**Reference: Westpointe Data Center – Response to DFT Comments  
PR-2020-004747 – Project Number  
SI-2024-00451 – Site Plan DFT**

This provides a response to review comments received April 17, 2024, from the Albuquerque Planning Department on 10 MW Data Center located at Daytona Rd NW between 94<sup>th</sup> St NW and 90<sup>th</sup> St NW.

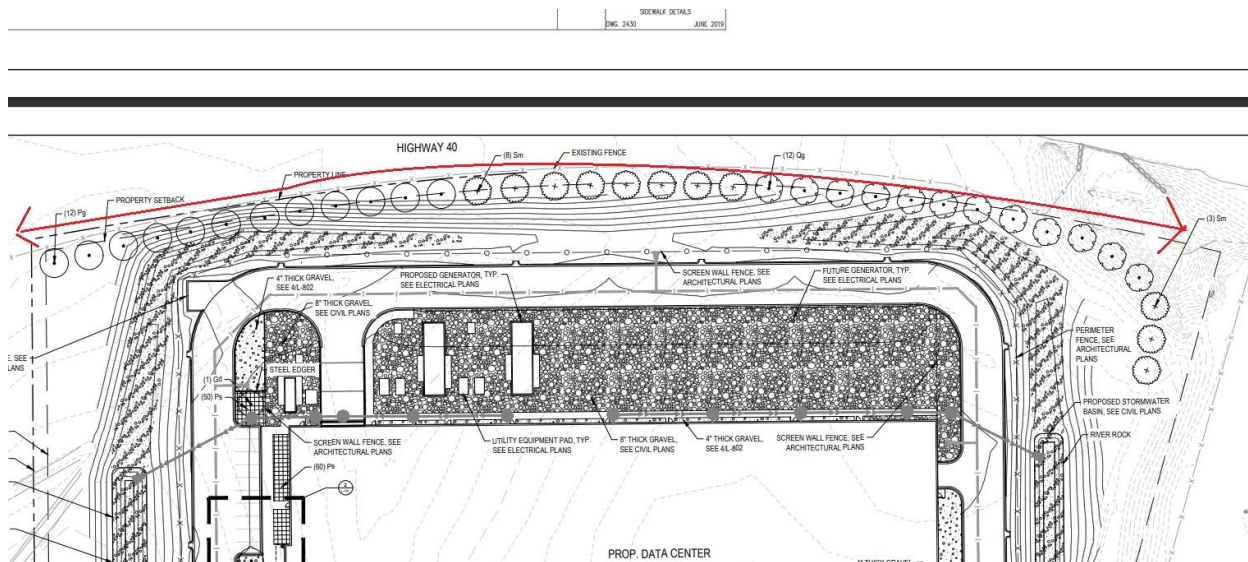
- Please explain why some areas of the site been left empty without landscaping. Add landscaping to the frontage of the site. Please see the marked-up image below for your reference:**

*The Landscape Plans have been updated to provide landscaping coverage over the previously empty areas. Trees have been added per City Staff recommendation on the frontage of the site.*

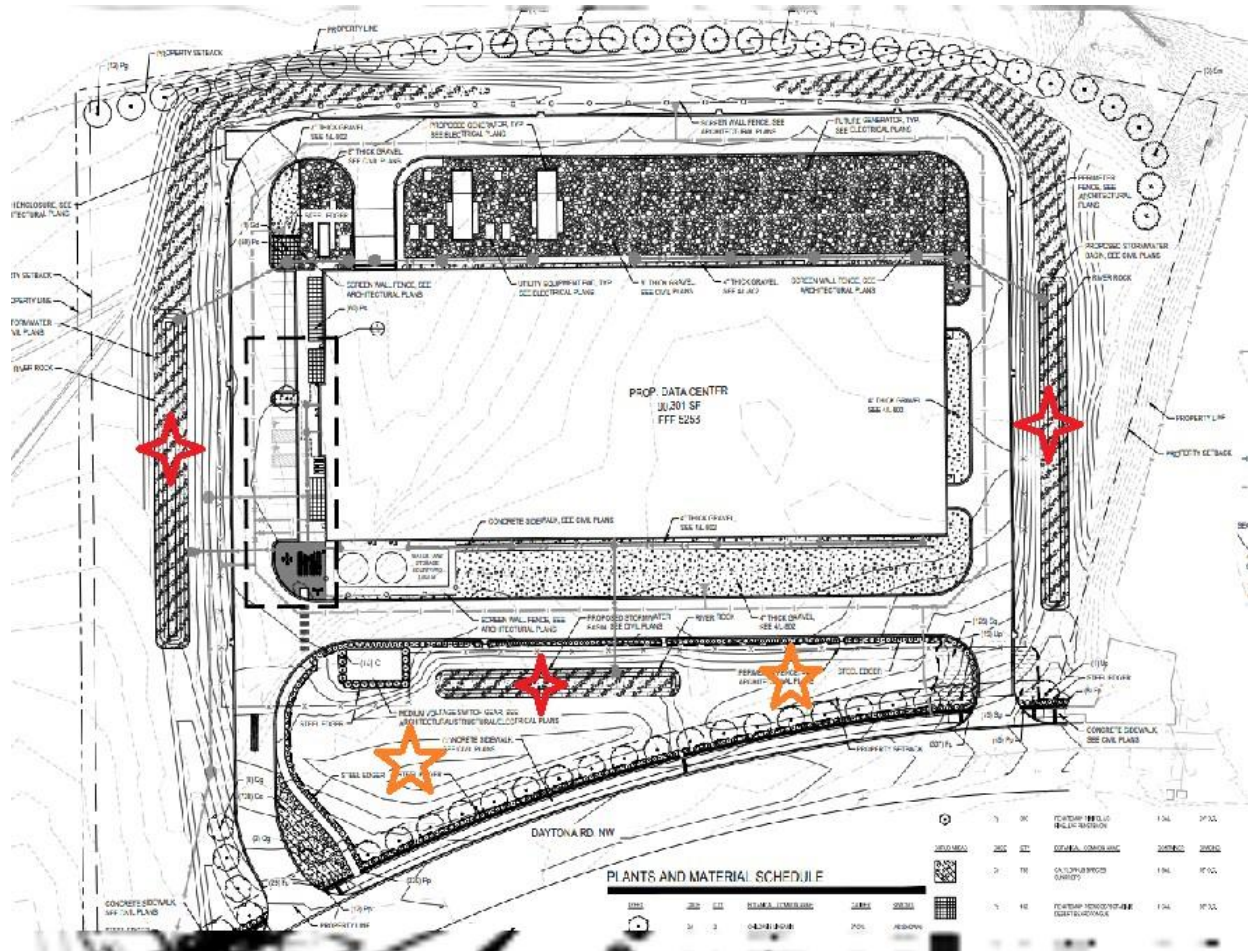
4. Along the rear stretch of the site, add large evergreen desert shrubs to enhance the provided tree buffer from Interstate 40. See the marked-up image below for your reference:

5. Please add trees to provide shade for the ponding area. Consider adding very large tree canopies in these areas. Please see the marked-up image below for your reference.

The landscape buffer from I-40 has been revised to provide an increased buffer per coordination with City Staff. Total shrubs for buffer provided are 141. 36 Curlleaf Mountain Mahogany, 35 Chamisa, 35 Apache Plume, 35 Texas ranger to enhance the buffer along the corridor.

The Landscape Plans have been updated to provide additional large trees for pond shading through coordination with City Staff. 12 *Ulmus Parvifolia*, 2 *Quercus Gris*, 2 *Sambucus Mexicana* and 1 *Prosopis Glandulosa* have been added adjacent to the stormwater basins.

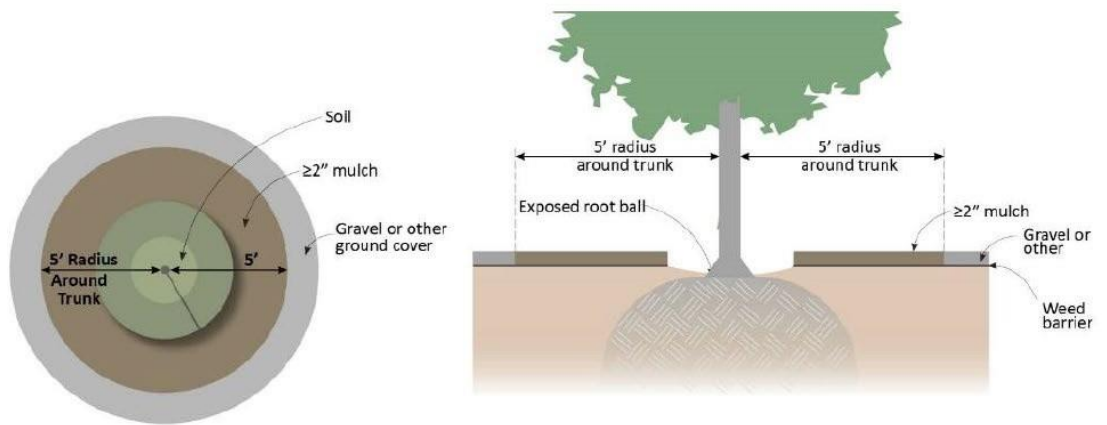
**Per 5-6(C)(5)(e), organic mulch is required as ground cover under trees within a 5-foot radius around the tree trunk, but not directly against the trunk. In these areas, weed barrier fabric is prohibited. (See figure below.)**

Modify your tree planting detail to reflect this requirement. The organic mulch used under the trees can be counted towards non gravel mulch used on the site as discussed earlier under 5-6(C)(5)(c). Please make sure you are mention 'Organic Mulch' on your planting details.

*Detail 02, 03, and 05 on Sheet L-802 has been updated to include Organic Mulch.*

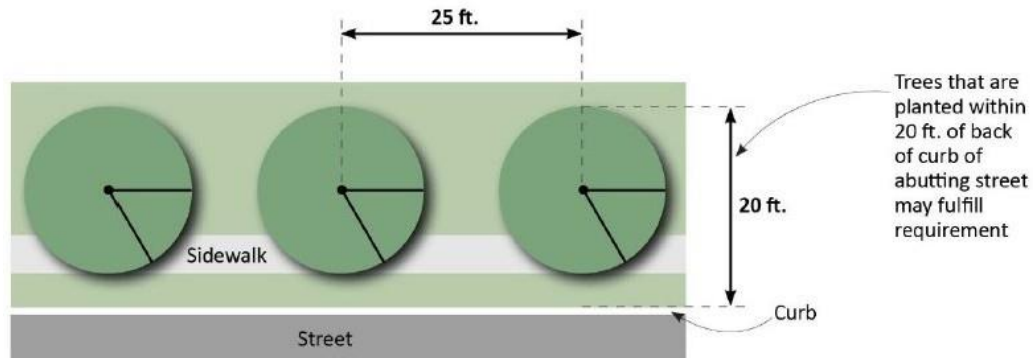
1. Per 5-6(C)(13)(a), required landscape and buffer areas shall be designed to serve as stormwater management areas to the maximum extent practicable and consistent with their required locations and vegetation. **Articulate how this project has considered this code.**

*The required landscape and buffer areas are designed to serve as storm water management by reducing the speed of water runoff into the detention pond. The peak discharge rate from the site is 13.0 CFS which is less than the 28.2 CFS allowed. The proposed swales will also include soil preparation with hand broadcast seed and angular aggregate rock to help with the storm water runoff erosion throughout the site as shown on Landscape Plan sheet L-101 and slope detail A1 on sheet L-803.*
